From: Boyle, Douglas J (DHS)
To: Derek S. Mills
CC: Fitzpatrick, Denise; Scott, Shannon; "cshort@werk-build.com"; Bartram, Stephen; "Allison.Richardson@indy.gov"; Bovard, Margie E.
Subject: RE: G BLOC - Reference ID #19284
Date: Thursday, April 11, 2019 5:23:00 PM
Attachments: [image001.png](#)
[image002.png](#)
[image003.png](#)
[image004.png](#)
[image005.png](#)

RE: Local Variance
G Bloc
841 E 64th Street
Indianapolis, Indiana

RE: G BLOC, 841 E. 64th Street – Local Variance (PIV location)

RE: G BLOC, 841 E. 64th Street – State Variance (FDC location)

Attachments: First Floor Plan, Landscape Plan, PIV 3D exterior view

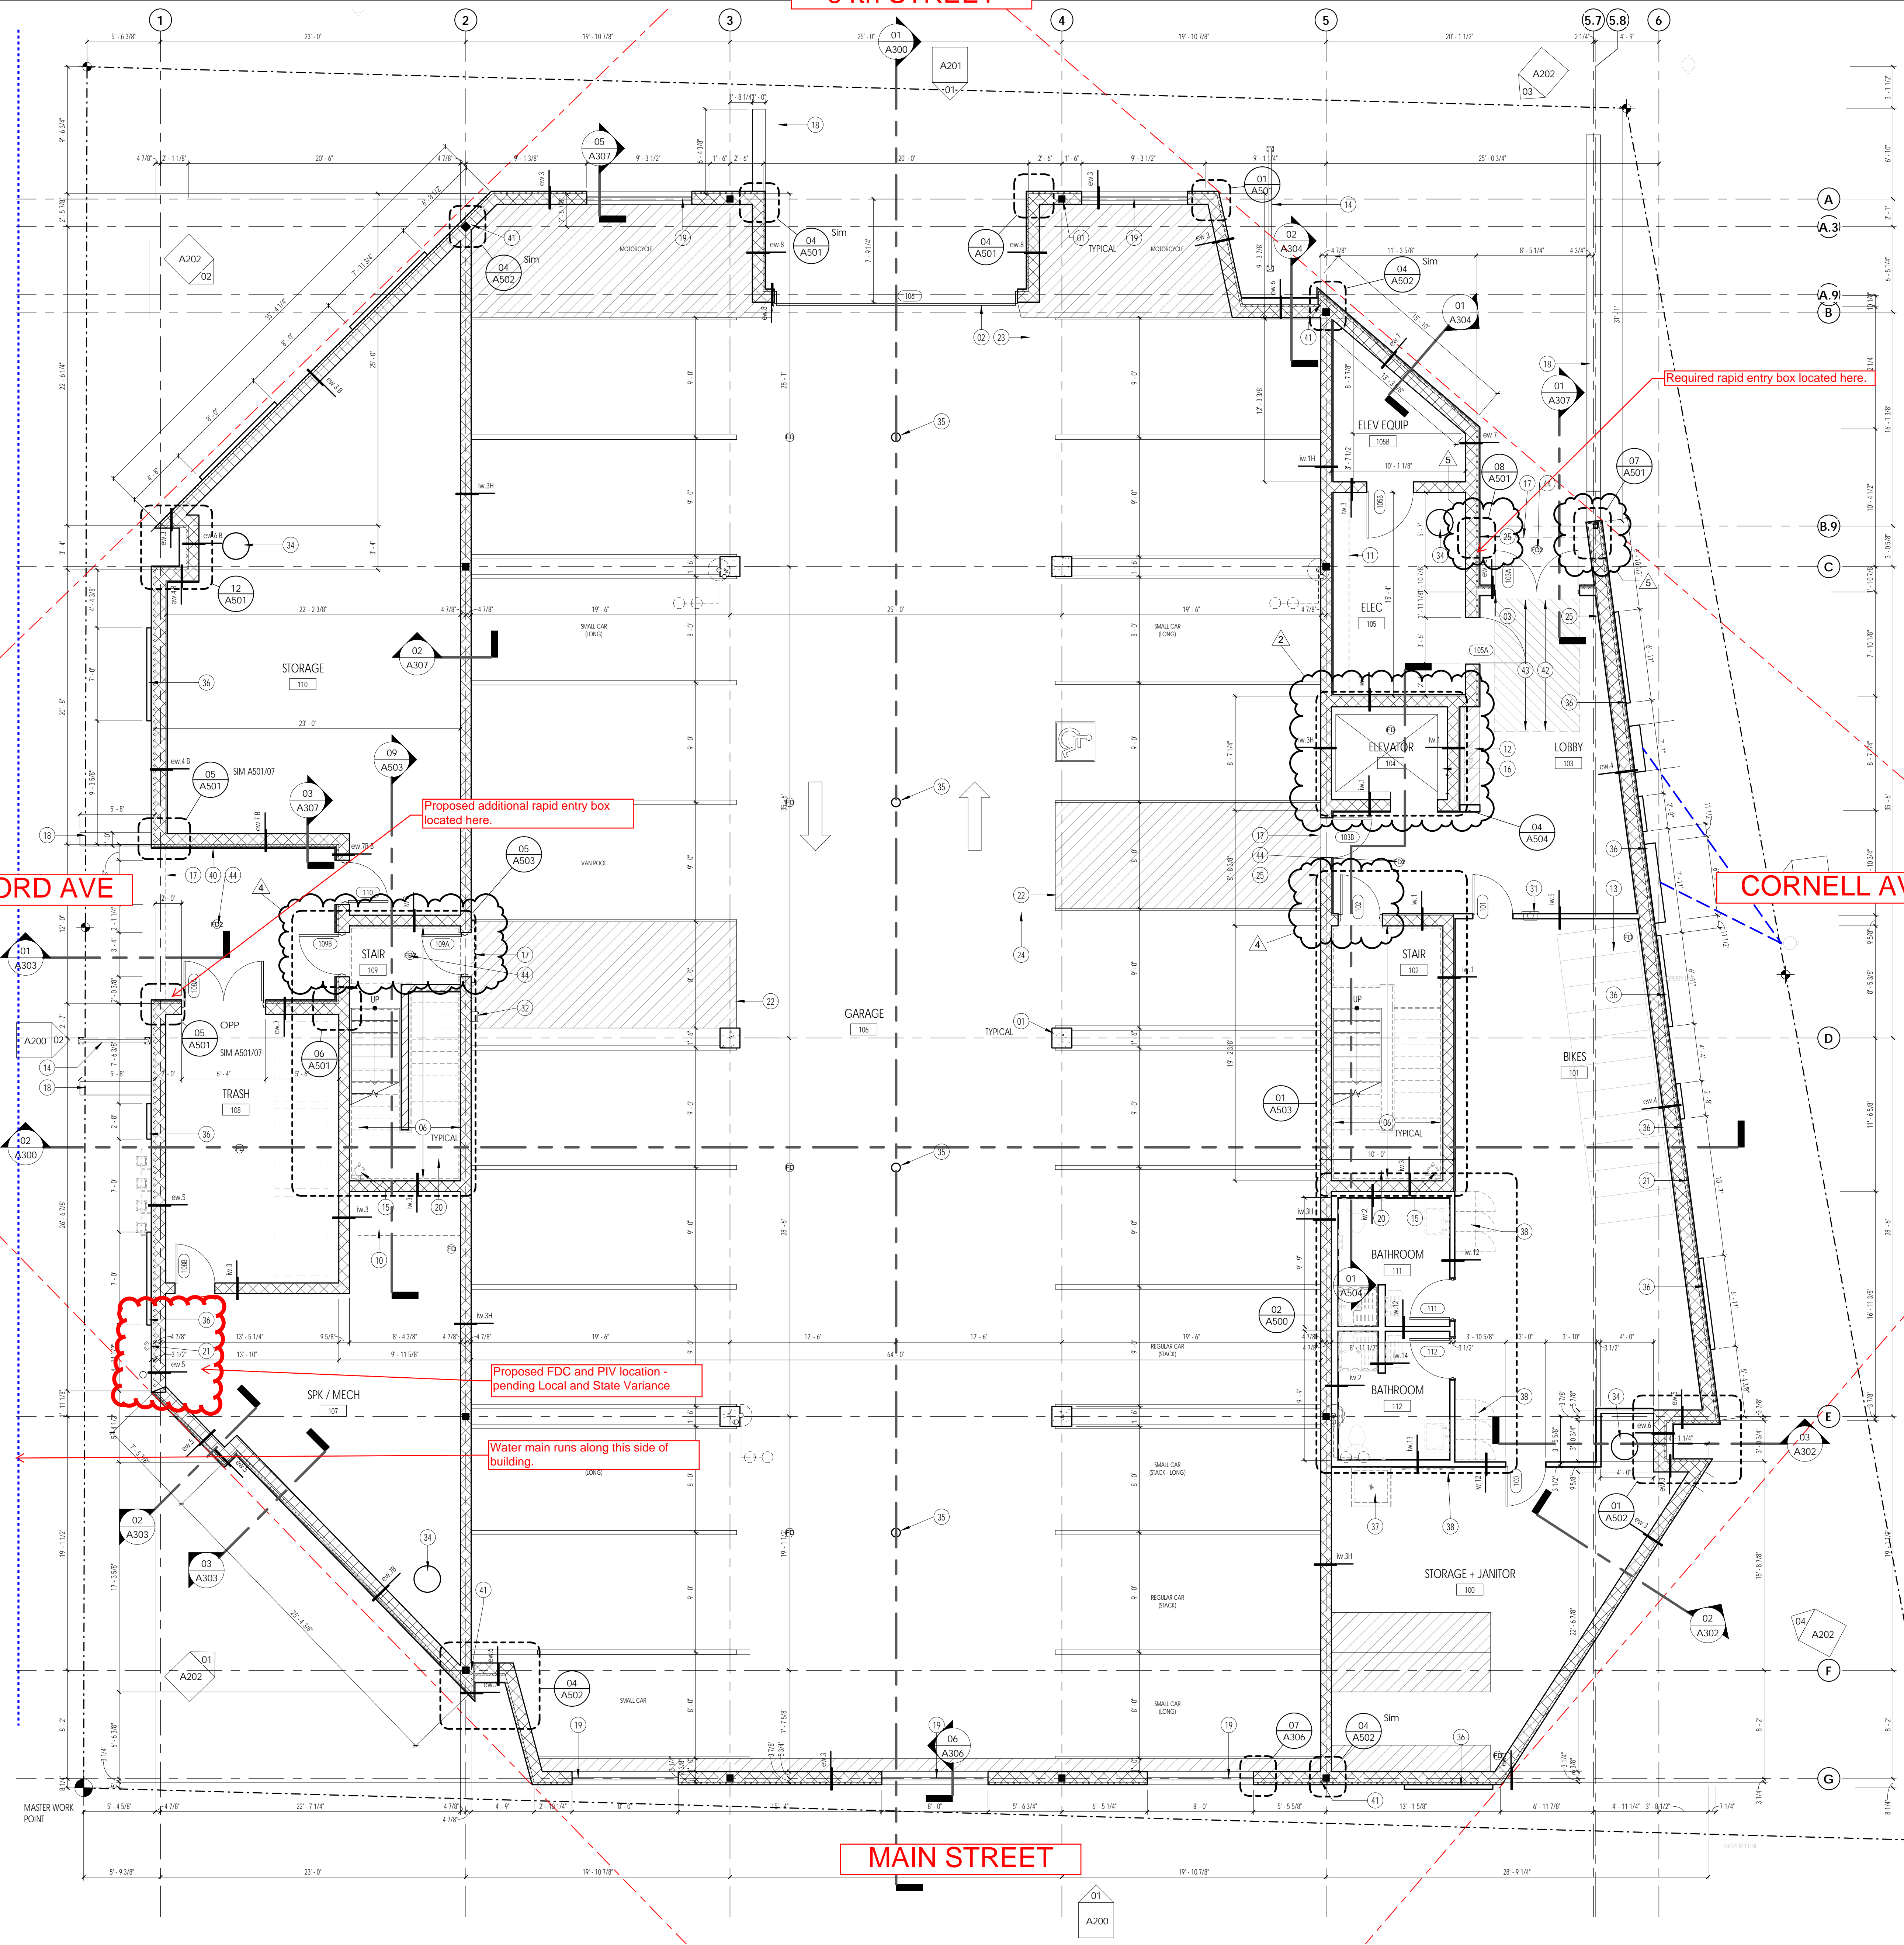
The requirement for a post indicator valve creates difficulties for this project due to the condensed site. The size of site, placement of building, and size of building eliminate the ability to have the PIV located 40' from the structure. If this distance were met the PIV would be located in neighboring properties and or the street.

The proposed location of the Post Indicator Valve is to be placed on the South West side of building as it relates directly to the existing water main running down Guilford Avenue and the proposed sprinkler room location. It is our intention to locate the PIV 5' away from the proposed FDC that will be located on the same side of the building which will also require a State Variance. We propose to install a rapid entry system at the front entry located on the North East, as well as a one located off the West entry which is in closer proximity to sprinkler room, FDC, PIV, and emergency stairwell with standpipe.

The requirement for a fire department connection creates difficulties for this project due to the location of water main, proposed PIV valve (pending Local variance), and proximity to sprinkler room. The proposed FDC location is not on the address side of the building (64th street), instead we propose it be placed on Guilford Ave. Due to the proximity of sprinkler room, PIV, and water main we believe the FDC location as proposed is located in a logical place from a construction, piping, and maintenance standpoint.

The proposed location of the FDC is on the South West side of building as this location is between the existing water main running down Guilford Avenue and the proposed sprinkler room location. It is our intention to locate the PIV 5' away from the proposed FDC that will be located on the same side of the building which we are currently working on a local variance for.

Based on the items listed in your letter dated March 20, 2019, a local variance to the above mentioned Section is granted by the Indianapolis Fire Department. A Post Indicator Valve will be closer than 40' from the building.
